Doc. No. BECO/ESR-1
SEPTEMBER 1984
REV. 1

Detailed Control Room Design Review

Executive Summary Report

Pilgrim Station

FIGURE 3-59.
RECIRCULATION SYSTEM
LOOP B

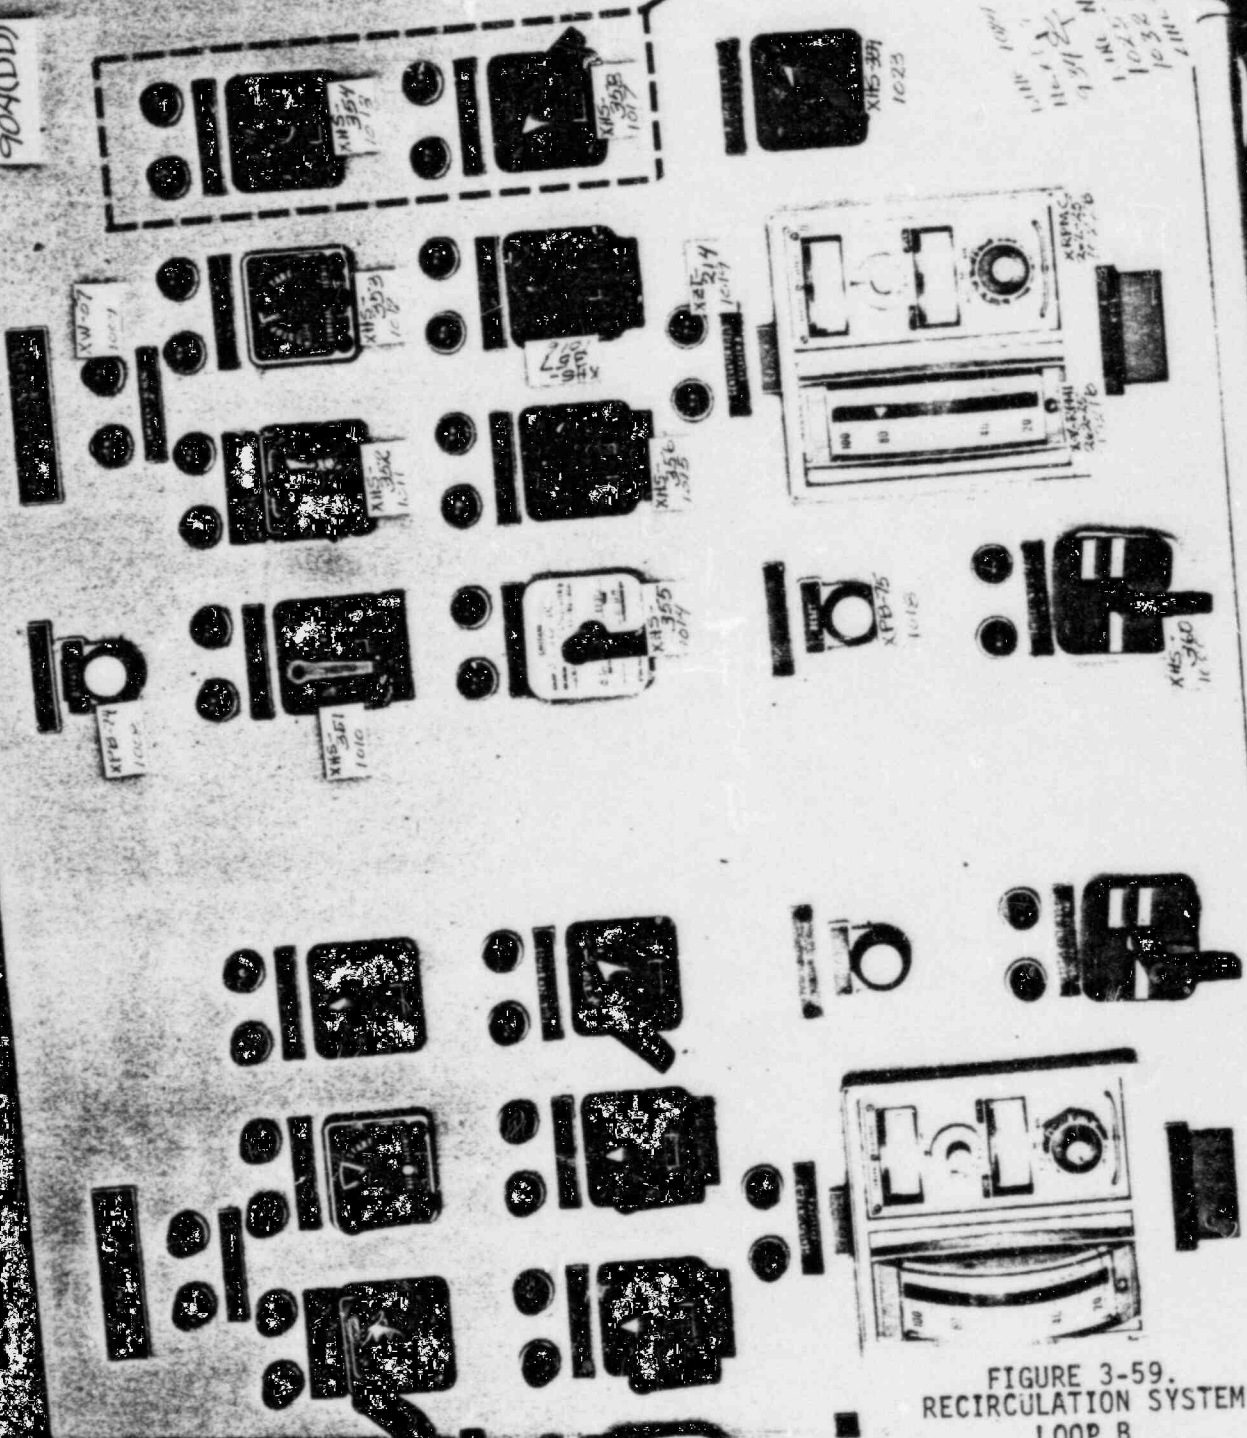
Figure 3-59 shows the recirculation system arrangement associated with HED 4B060.5. The loops A and B bypass valves control switches have been abandoned.

FIGURE 3-62.
CONTROL ROD DISPLAY

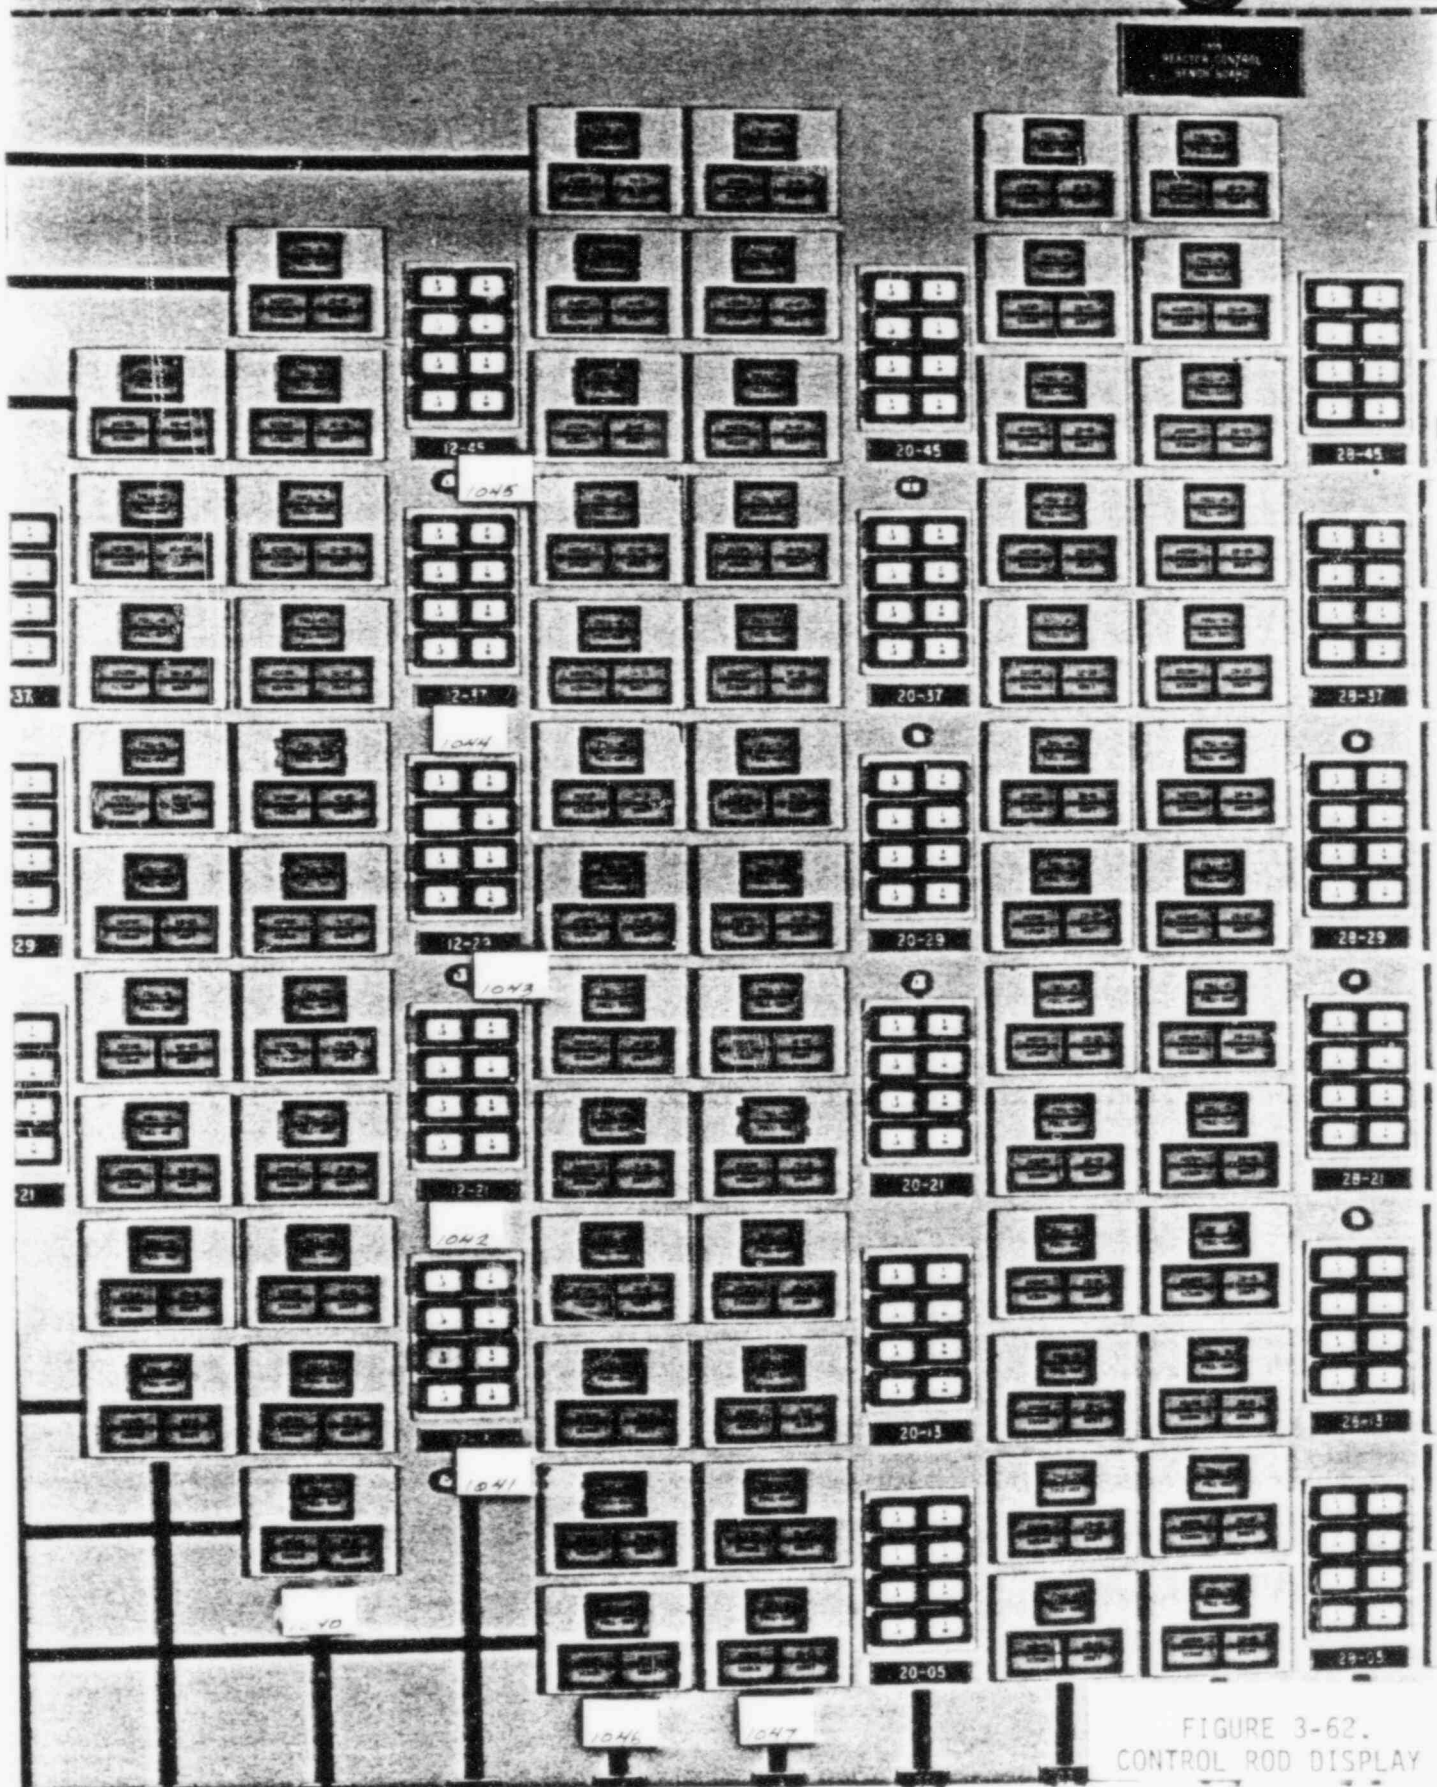
Figures 3-61, 62, and 63 show the rod control matrix lights and Figure 3-73 shows the rod selector push buttons associated with HEDs 8B094.5 and 4B027.5. The human factors problems of a maximum light string length will be overcome by demarcation; it will also be coordinated with demarcation on the rod selector push buttons. The barrier problem for the push buttons will be included in the final layout.

ENHANCE WITH
DEMARCATON

FIGURE 3-63.
CONTROL ROD DISPLAY

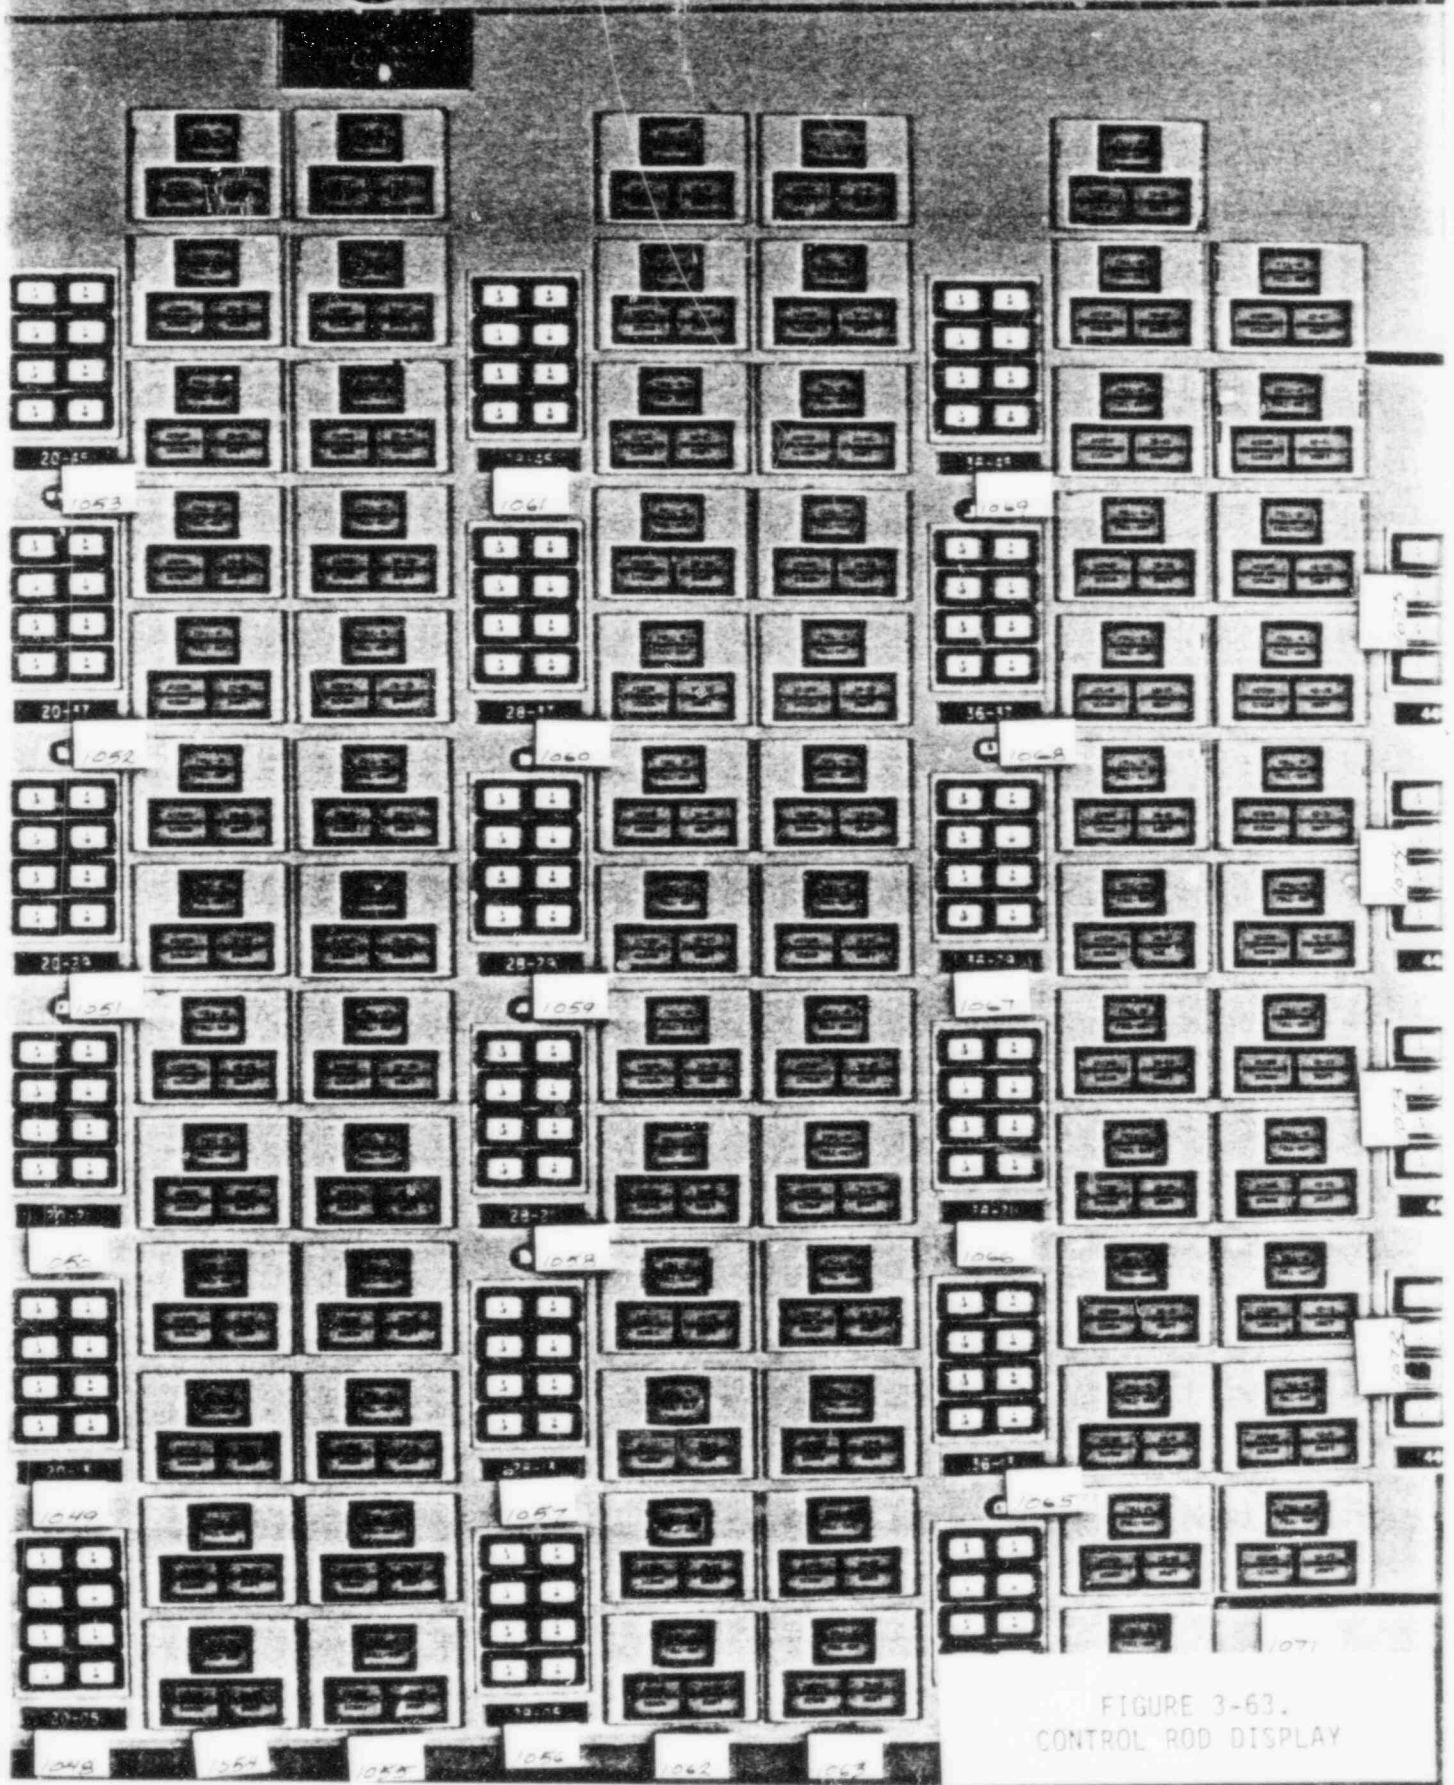
ENHANCE WITH
DEMARCATON

FIGURE 3-69. NUCLEAR INSTRUMENTS AND REACTOR VESSEL LEVEL

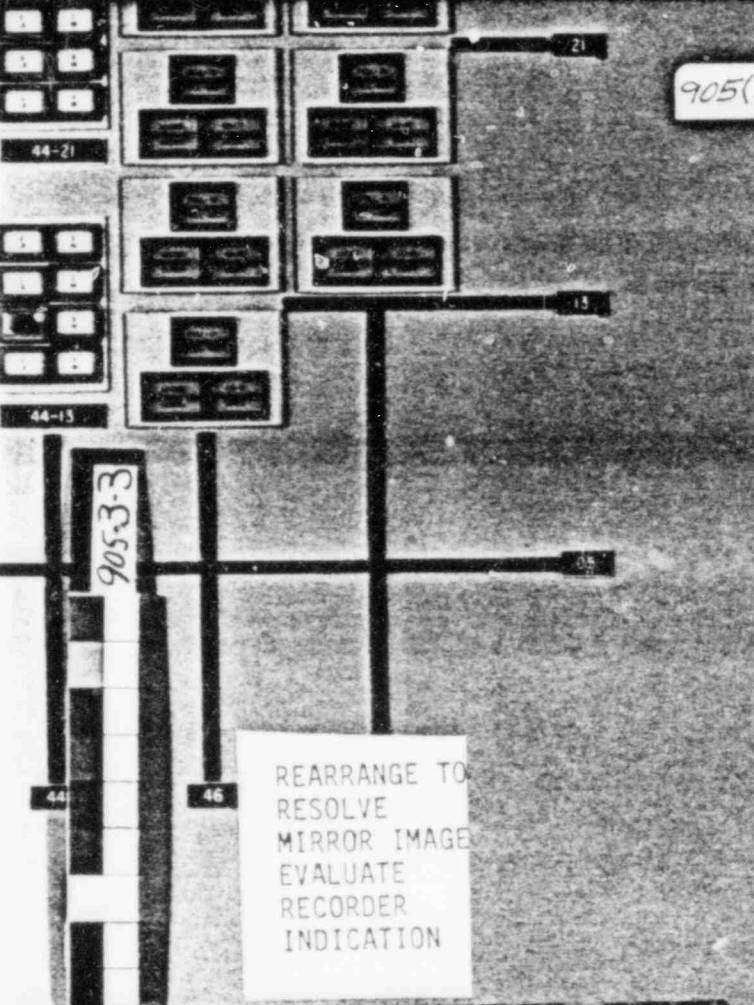
Figure 3-69 shows the present location of the steam flow/reactor level recorder selector switch. HED 9B107.5 requires that it be relocated in close proximity to the recorders shown on Figure 3-70. This requirement is part of the final layout.

RELOCATE

FIGURE 3-72.
NUCLEAR INSTRUMENTS

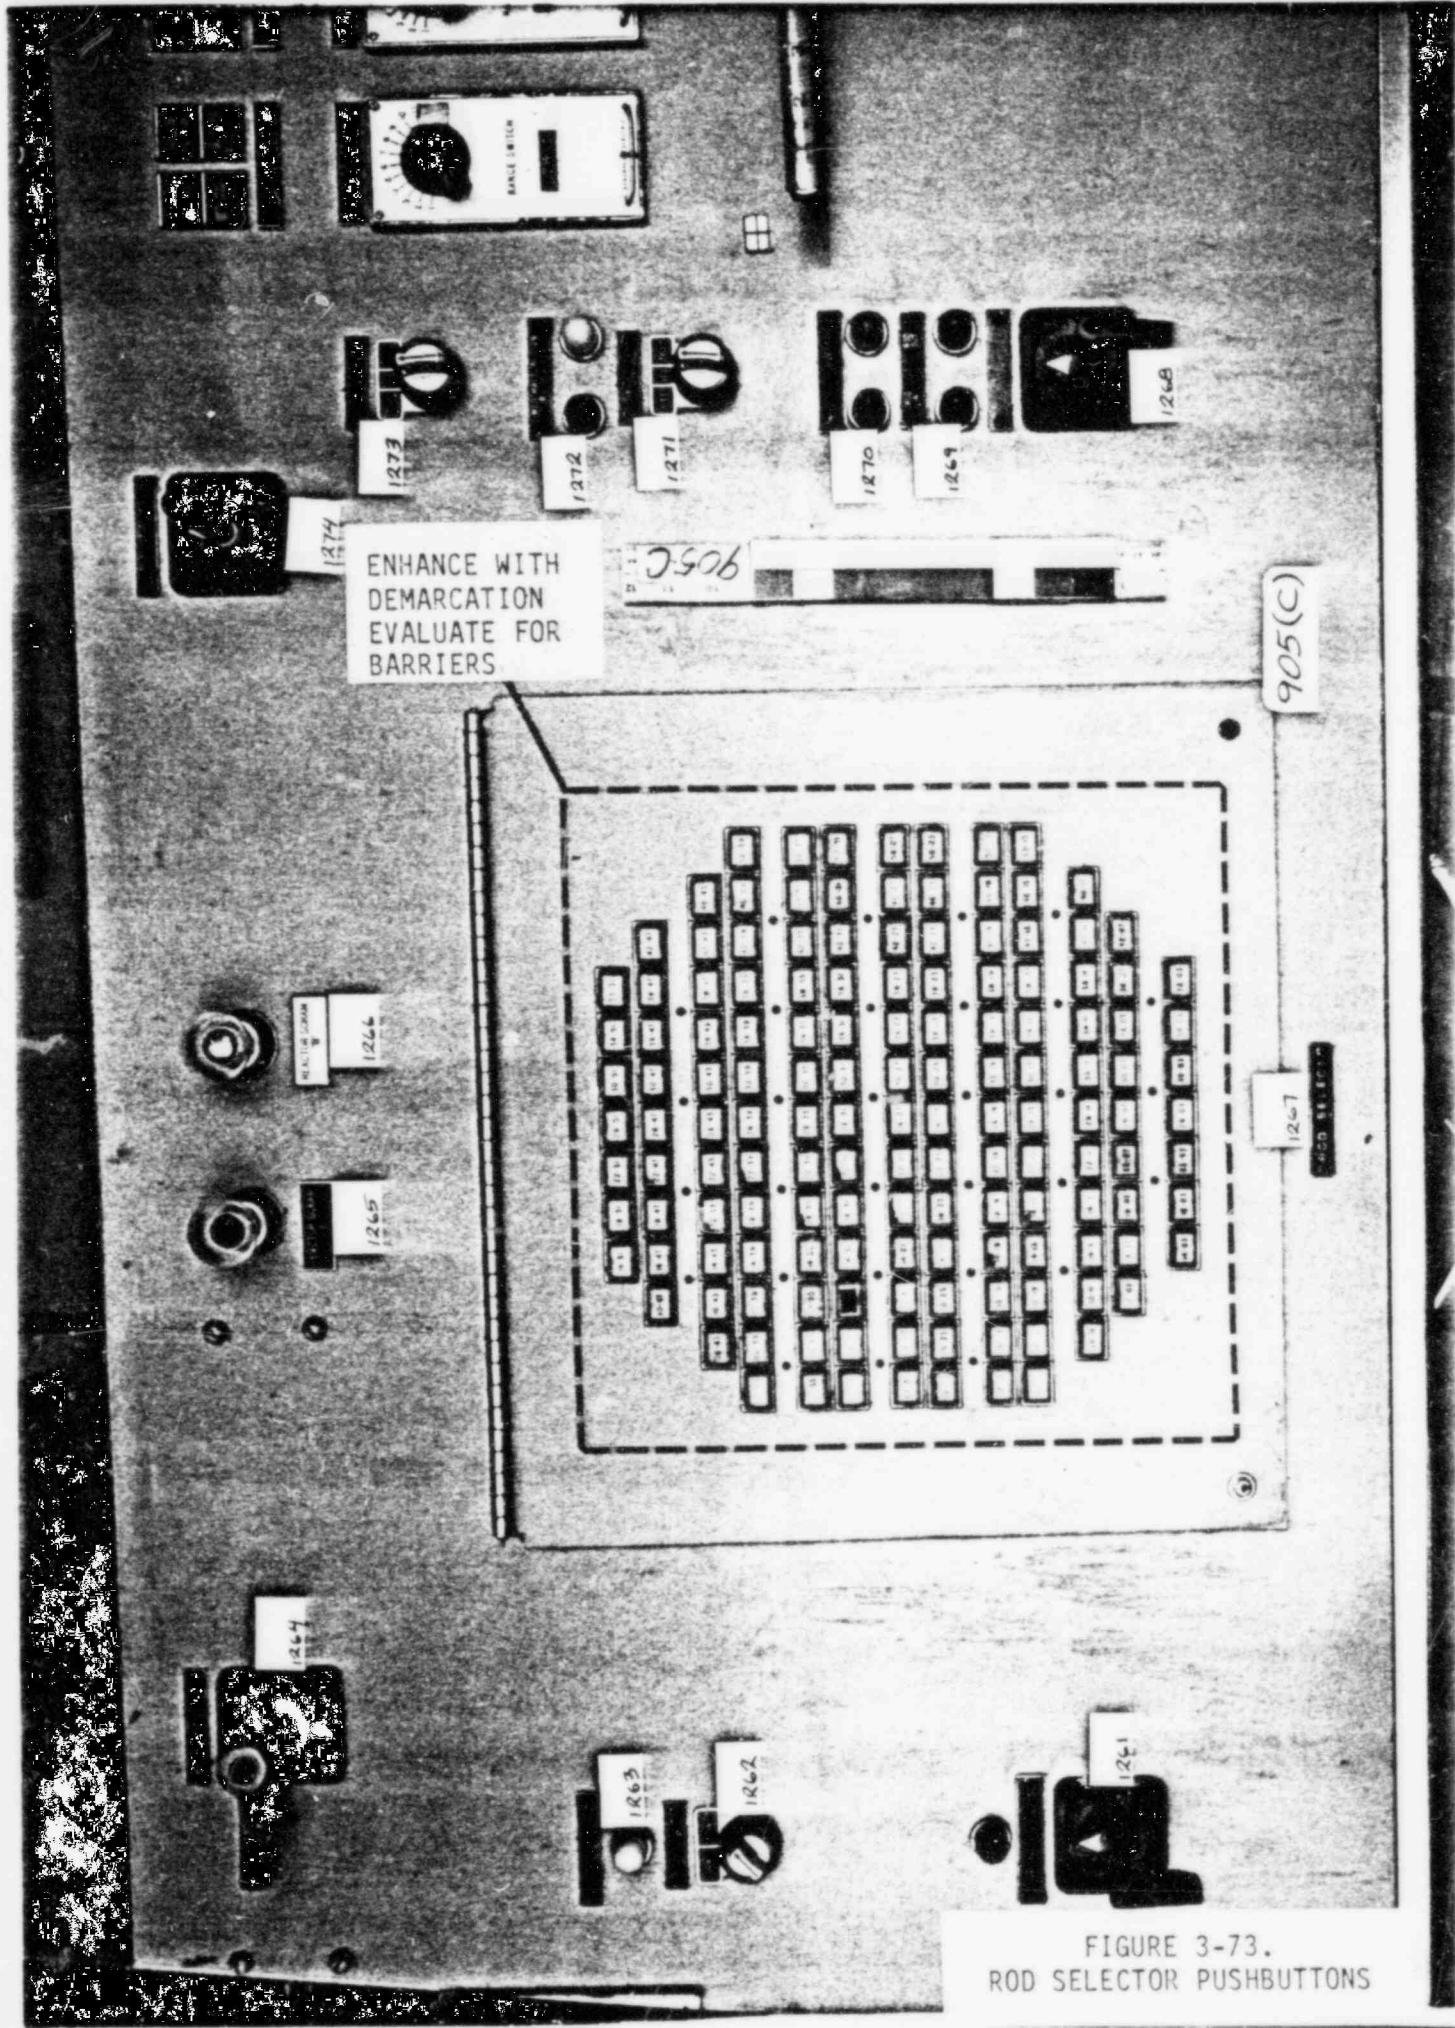
Figure 3-72 shows the master recirculation flow control switch that is deleted by HED 4B060.5.

DELETE
